DRAINAGE REPORT for VISTA DEL NORTE, NORTH POND

Re: Las Lomitas Industrial Park Drainage Report Engineer's Stamp dated 1-18-05 (D16/D2)

Las Lomitas Industrial Park Drainage Report Re: Engineer's Stamp dated 11-19-04 (D16/D2)

Drainage Management Plan

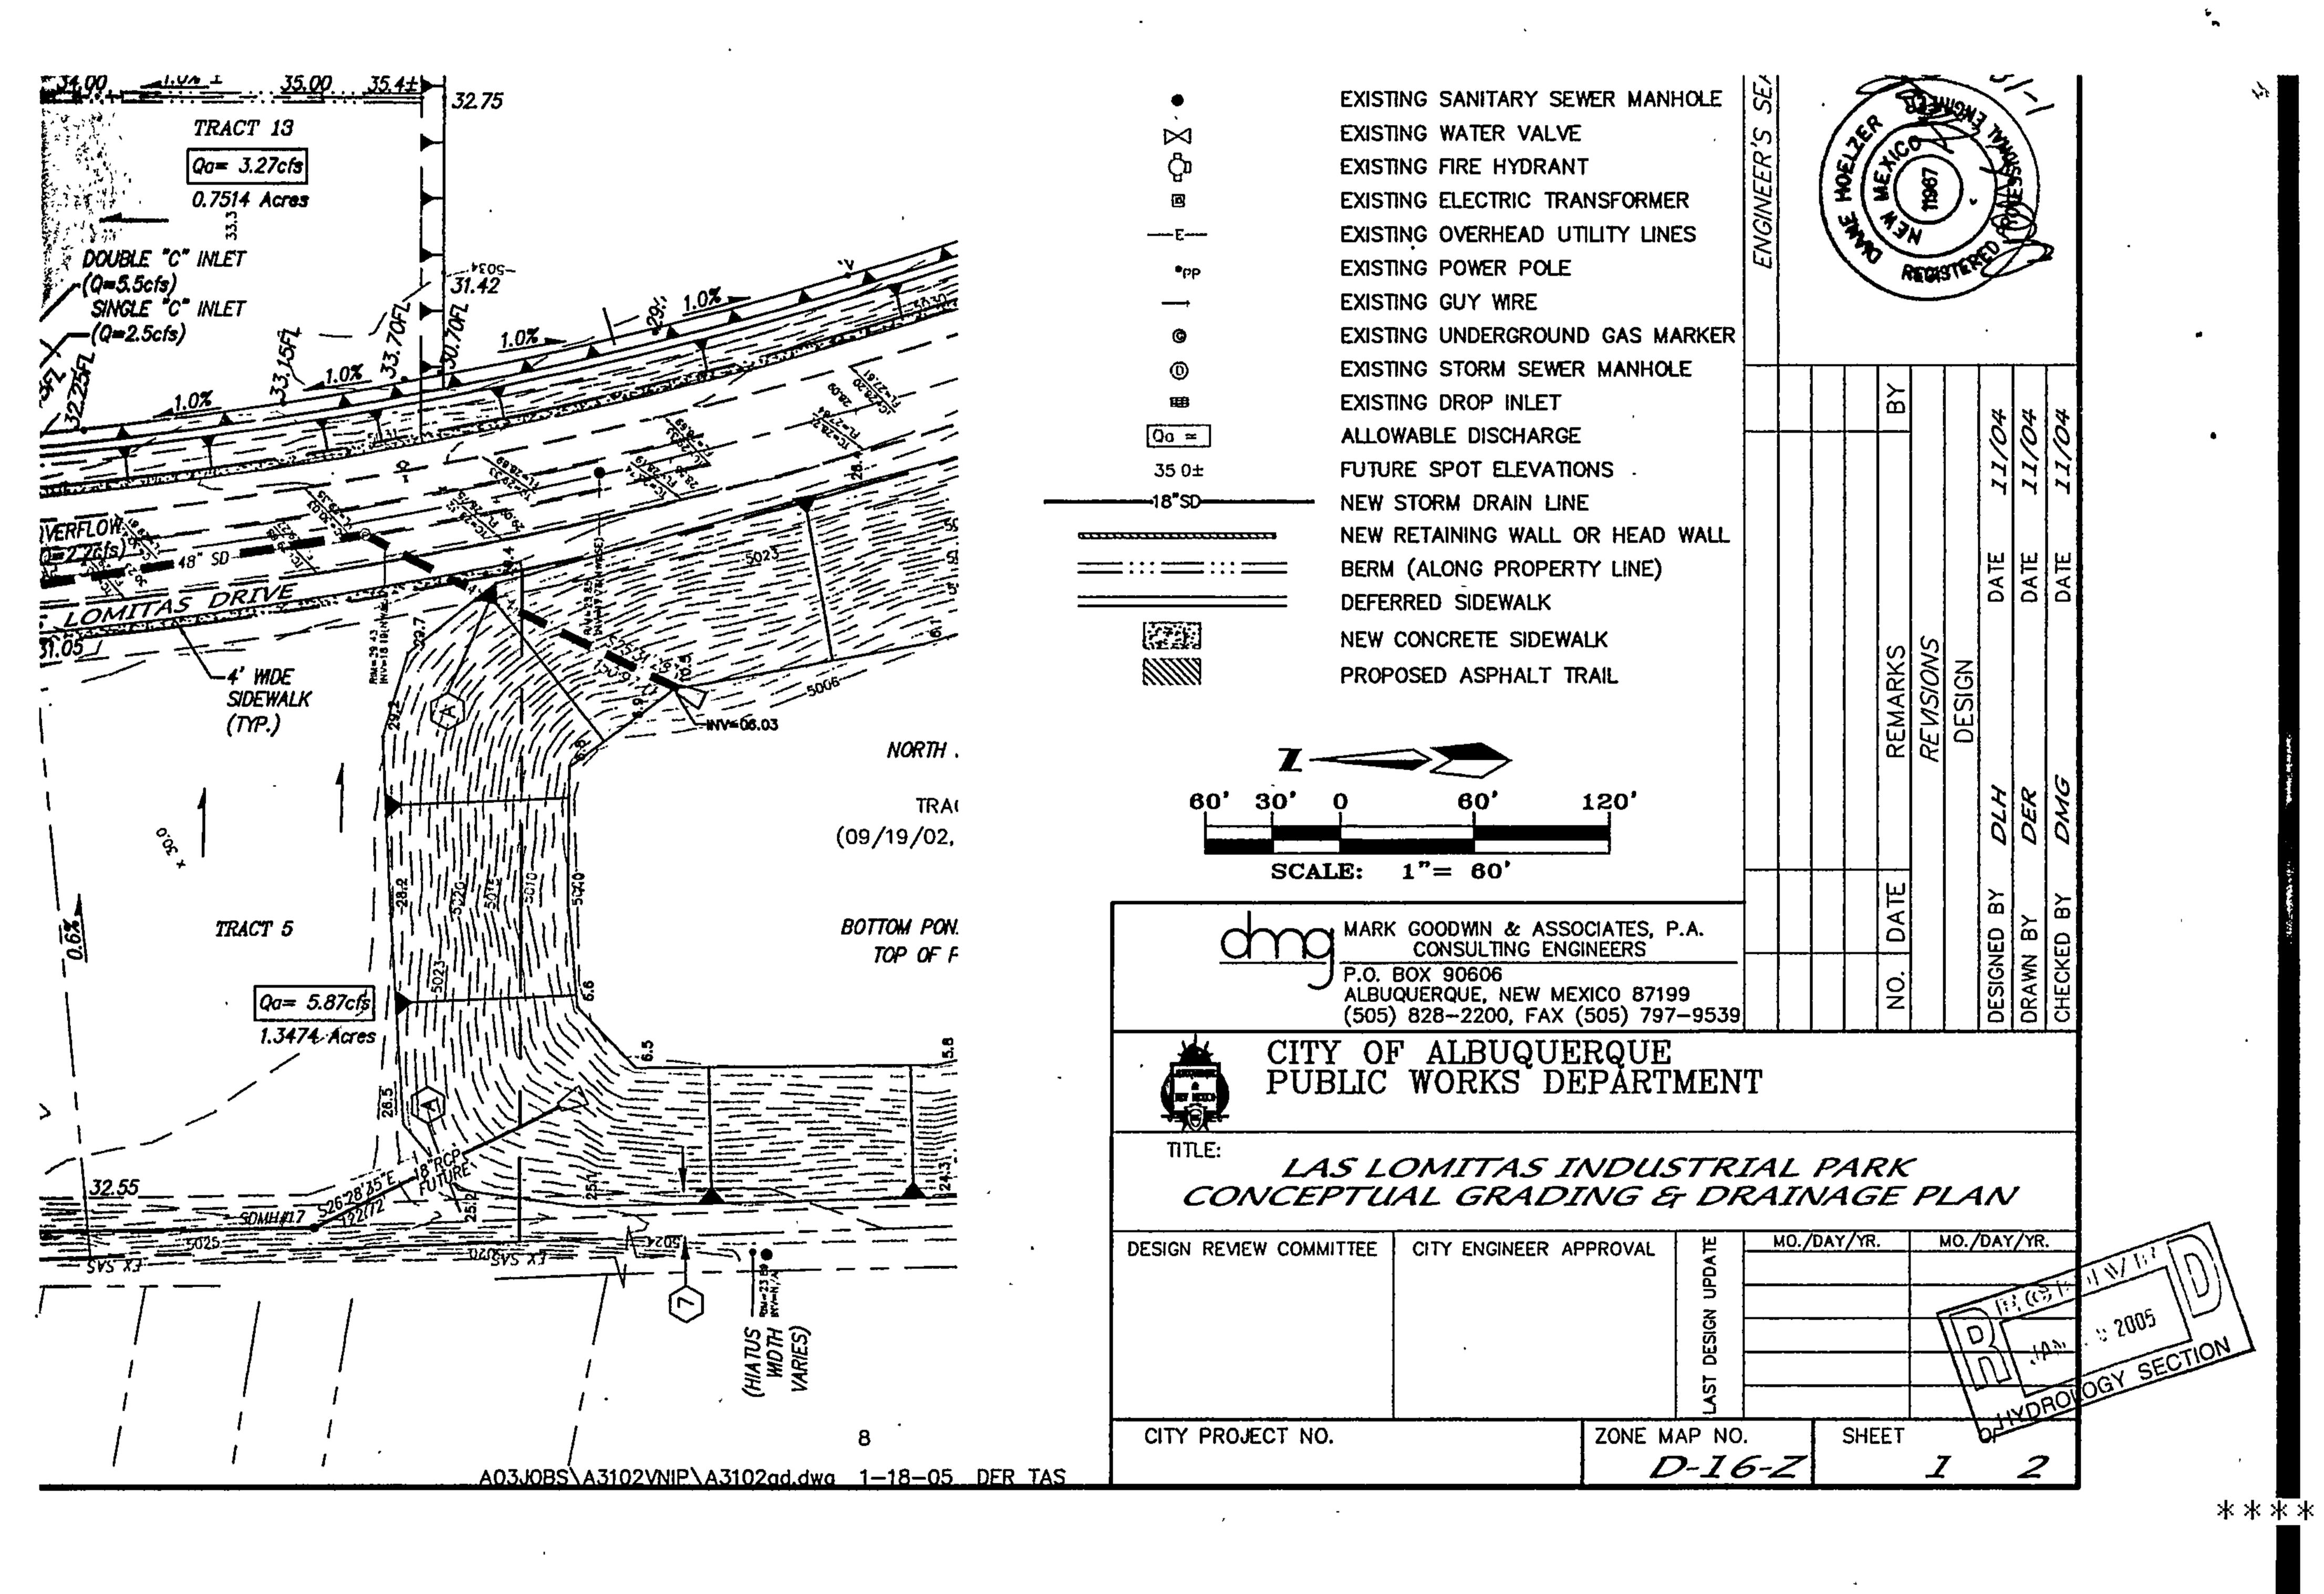
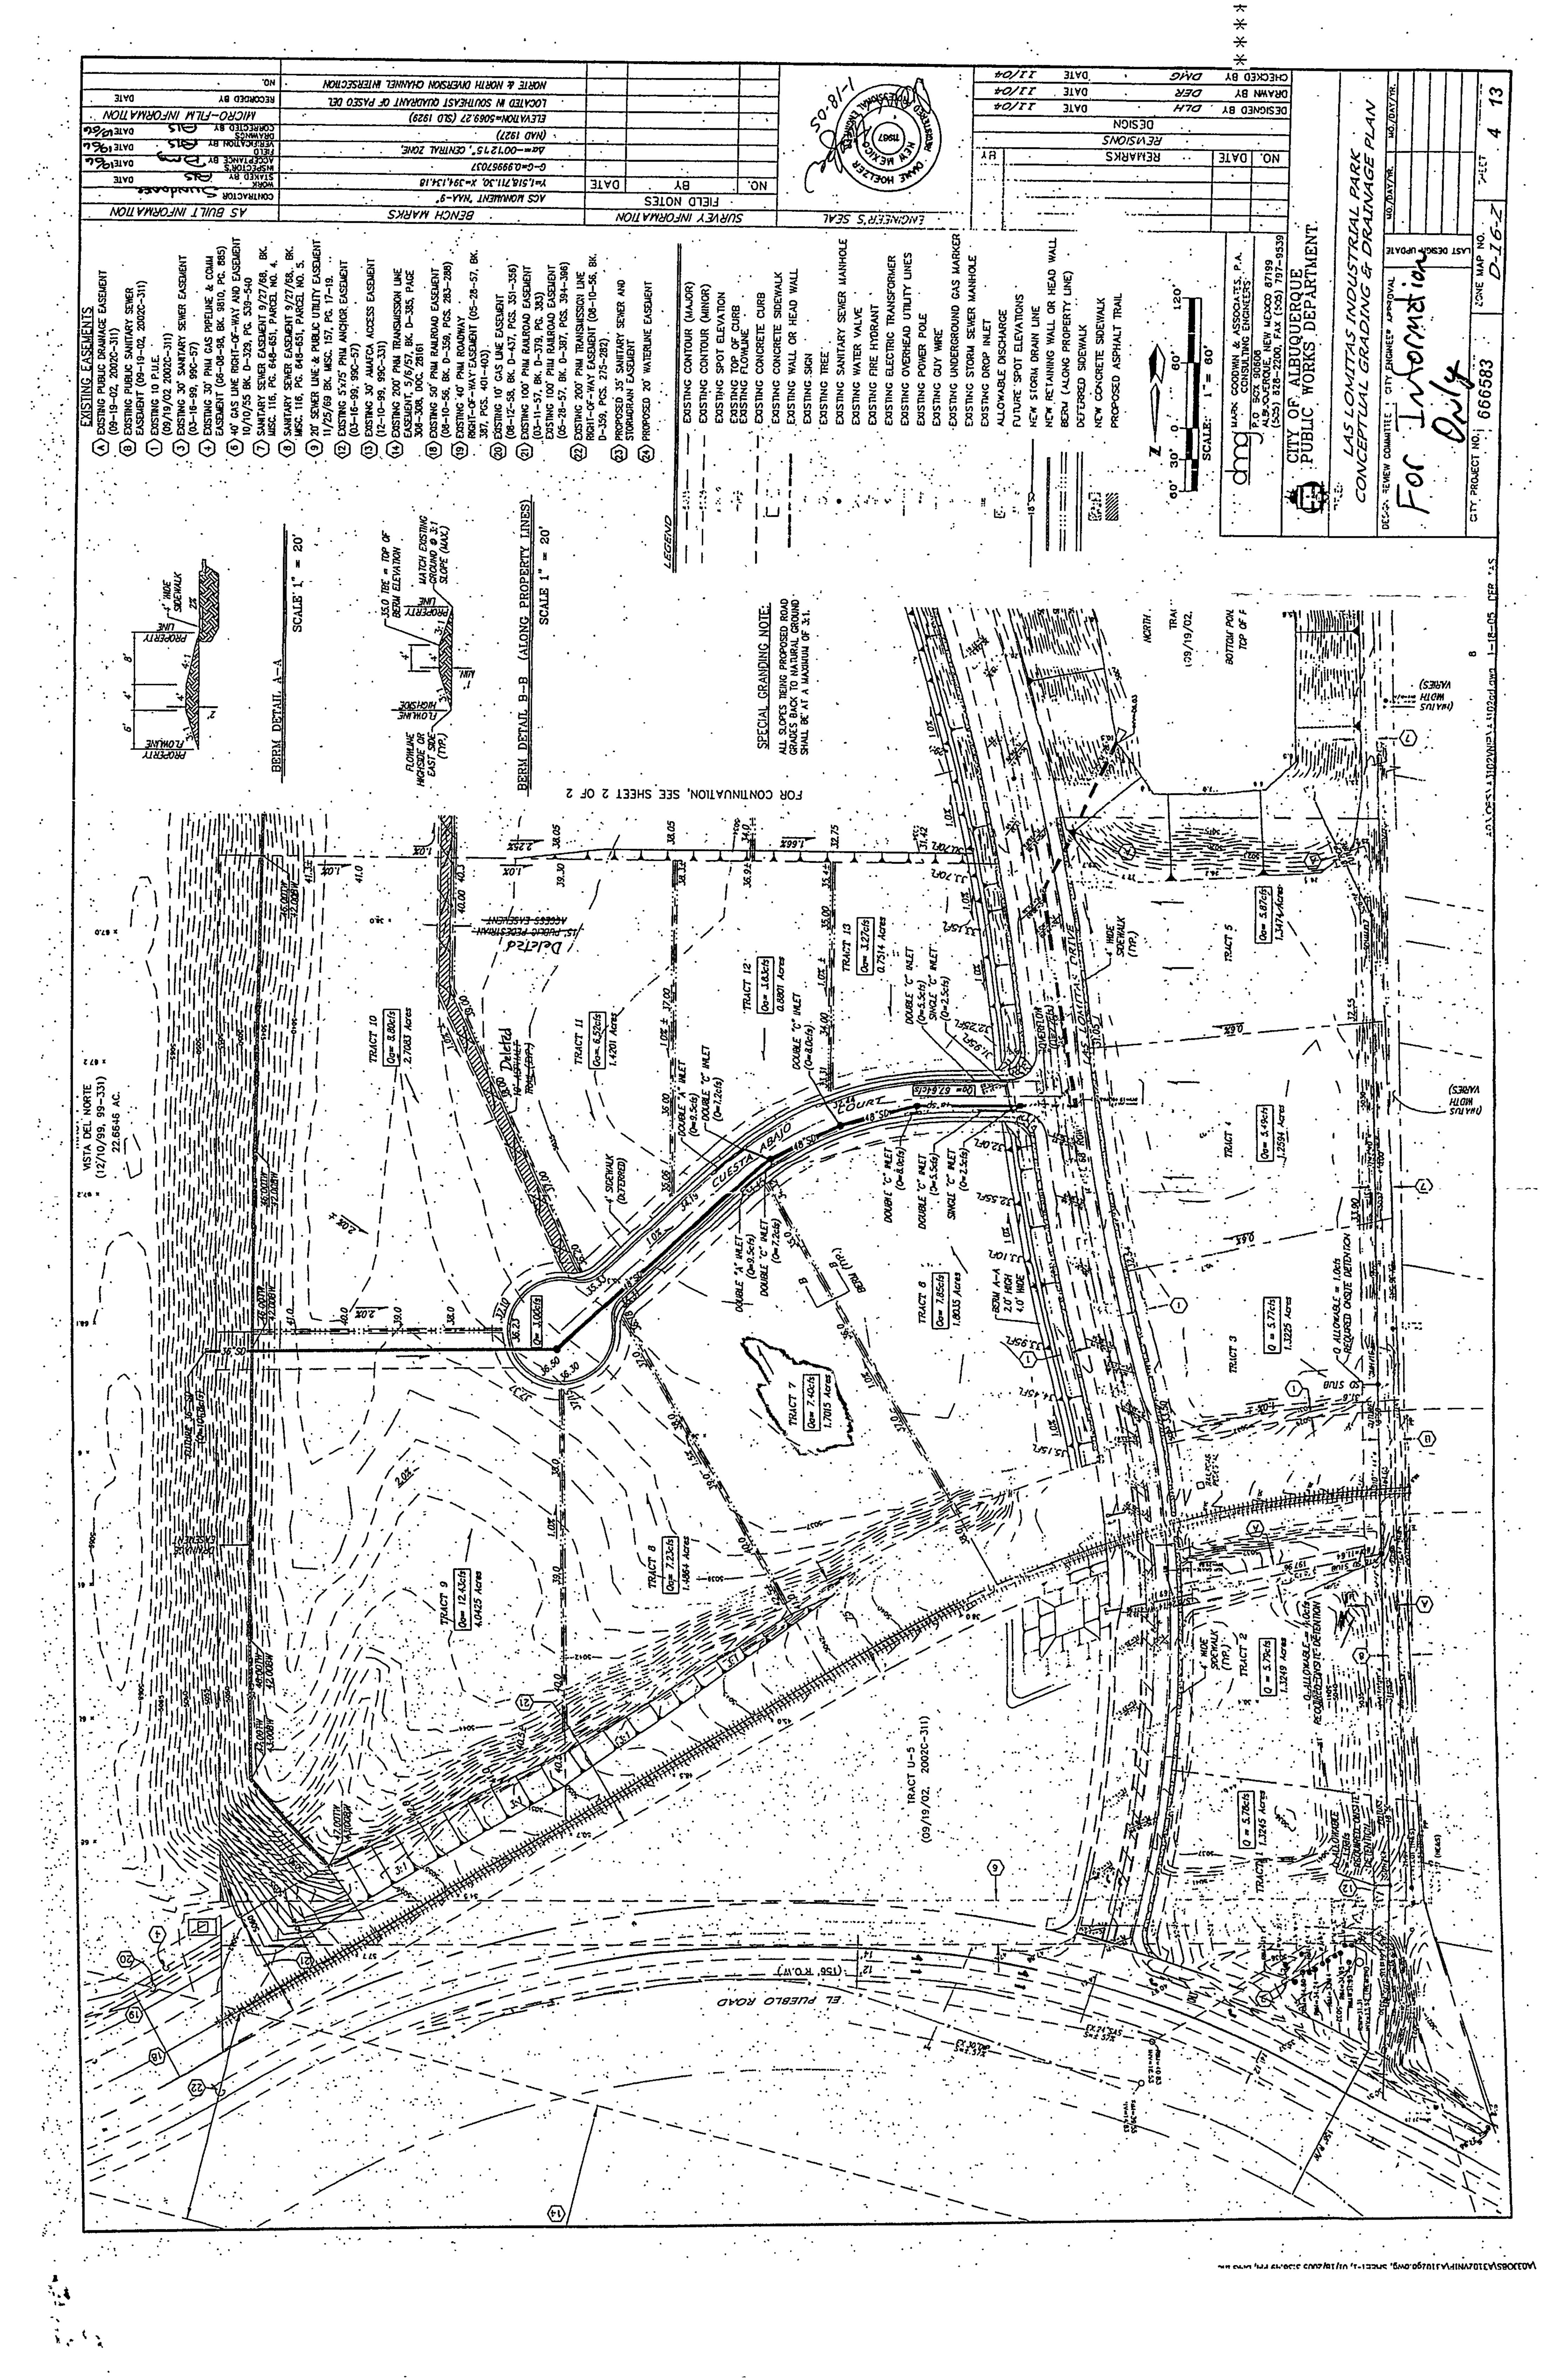
- The berm at Las Lomitas must be entirely on the westernmost lots and no slope should be in the R/W. The maximum slope in the R/W should be 2%.
- Your grading plan shows that the water surface elevation of 5020 encroaches into Tract 5 by at least 25 feet. I would need a public drainage easement to this contour plus 10 feet. It also shows proposed grading of the pond that would keep the pond entirely on Tract U-1. If this were your intent, it would have to appear on your infrastructure list and be done by Work Order.

- Please provide an interim-grading plan showing what you will be grading. This plan should show berms at all property lines.
- Tracts 3-5 are only allowed free discharge if they drain to Las Lomitas. If these lots are proposed to drain to the pond outfall pipe, they must be constrained so as to not exceed the 4.65 cfs allowable. Lots 1 and 2 must likewise be constrained (0.15 cfs per your report). Your AHYMO output must show this.

- Please provide calculations that the 36" pipe can drain your site as well as Tract T-4. From the as-built of Las Lomitas provided, you were only expecting 97.5 cfs in the 48" and now it supposed to handle 150 cfs. Please provide a new HGL analysis of this storm drain.

- Please quantify the existing offsite flow from Tract T-4 or any other source.

Approval Denied See revised Ala submitted 1/19/2005
